This report documents the technical evaluation of the adequacy of the station electric distribution system voltages for the Peach Bottom Atomic Power Station, Units 2 and 3. The evaluation is to determine if the onsite distribution system, in conjunction with the offsite power sources, has sufficient capacity to automatically start and operate all Class IE loads within the equipment voltage ratings under certain conditions established by the Nuclear Regulatory Commission. The analysis submitted indicates that the capacity is sufficient to meet the NRC requirements provided specific plant procedures are followed for shutting down the second unit after an accident in the first unit and with a loss of one offsite source.

TECHNICAL EVALUATION REPORT ON THE ADEQUACY OF STATION ELECTRIC DISTRIBUTION SYSTEM VOLTAGES FOR THE PEACH BOTTOM ATOMIC POWER STATION, UNITS 2 AND 3

(Docket Nos. 50-277, 50-278)

PICTAR 1 PEACH BOTTOM ATOMIC POWER STATION ELECTRICAL ONE-LINE DIAGRAM

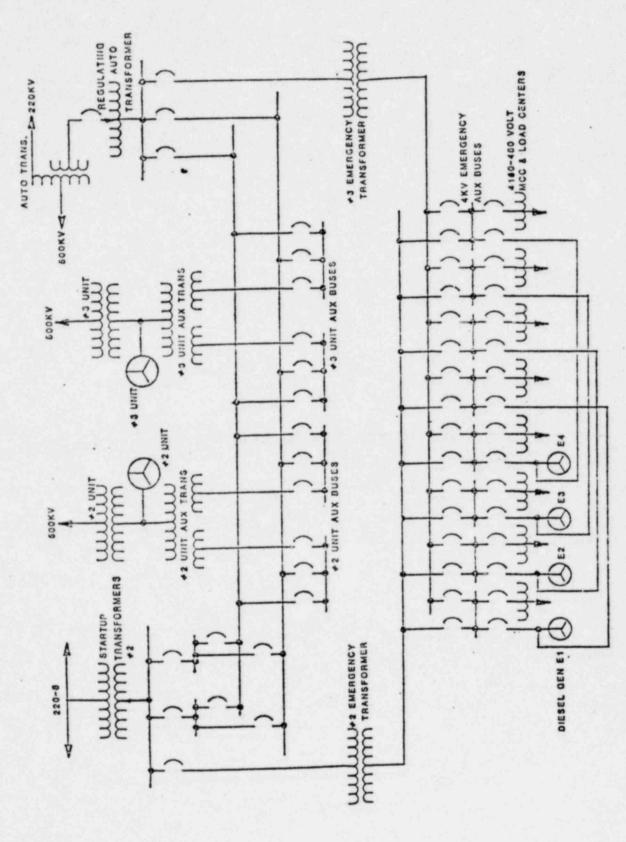
A one-line diagram of Peach Bottom Atomic Power Station's, Units 2 and 3 (Peach Bottom) electrical distribution system is shown in Figure 1. This figure was adapted from Figure 1 of a September 15, 1976 Philadelphia Electric Company letter to the NRC [Ref. 10]. There are eight 4160-volt Class 1E buses. Under normal operating conditions these buses are energized from the offsite power sources through emergency transformers No. 2 and No. 3. Emergency transformer No. 2 is energized by startup transformer No. 2 which is equipped with automatic tap changers that begin to index every 3-5 seconds after an initial 30-second time delay. Emergency transformer No. 3 is energized by a 50 MVA regulating auto-transformer. Upon shutdown of a main generator because of an accident or a transient trip, the unit auxiliary buses (normally supplied by the generator) are automatically transferred to the offsite power source.

The Class IE equipment at Peach Bottom is protected from a loss of voltage by relays monitoring the Class IE bus feeders. The setpoint of these relays is between 2275 volts and 2450 volts. These relays initiate tripping of the Class IE bus from the offsite source. A second-level of undervoltage protection has also been proposed by the licensee. The proposed relay setpoints are $90\% \pm 2\%$ of 4160 volts with a time delay of 60 seconds $\pm 5\%$ if there is no accident signal present. When an accident signal is present the time delay is reduced to 6 seconds. Additional information on this proposed modification is available under separate cover. The report is titled "Technical Evaluation of the Proposed Modifications and Technical Specifications changes on Grid Voltage Degradation (Part A) for the Peach Bottom Atomic Power Station, Units 2 and 3" (Tac Nos. 10039 and 10040).
